USB 3.1 ENGINEERING CHANGE NOTICE FORM

Title: LFPS Typos Applied to: USB3.1

Section 6.9.2, Figure 6-30

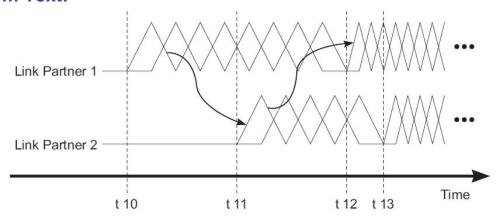
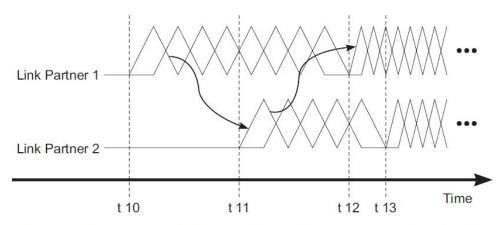
Brief description of the functional changes:
Corrections to typographical errors on page 6-46. No functional changes.
Benefits as a result of the changes:
The change will eliminate confusion caused by the typographical errors.
An assessment of the impact to the existing revision and systems that currently conform to the USB
specification:
No impact.
An analysis of the hardware implications:
No impact.
An analysis of the software implications:
No impact.
An analysis of the complement to the plane for the section
An analysis of the compliance testing implications:
No impact.

From Text:

- t10 When Link Partner 1 starts to transmit LFPS, in initiating exit from either U1/U2/U3/Loopback.
- t11 When Link Partner 2 validates the received LFPS for the required t11-t10 duration and starts to transmit LFPS in response.
- t12 When Link Partner 1 validates the received LFPS of the required t12-t11 and t12-t10 durations and starts to transmit SS signaling.
- t13 When Link Partner 2 transmits LFPS of meeting the required t13-t11 duration and starts to transmit SS signaling.

To Text:

- t10 When Link Partner 1 starts to transmit LFPS, in initiating exit from either U1/U2/U3/Loopback.
- t11 When Link Partner 2 validates the received LFPS for the required t11-t10 duration and starts to transmit LFPS in response.
- t12 When Link Partner 1 validates the received LFPS of the required t12-t11 and t12-t10 durations and starts to transmit SS or SSP signaling.
- t13 When Link Partner 2 transmits LFPS of meeting the required t13-t11 duration and starts to transmit SS or SSP signaling.

Note: the timing diagram in Figure 6-30 is for illustration of the LFPS handshake process only.
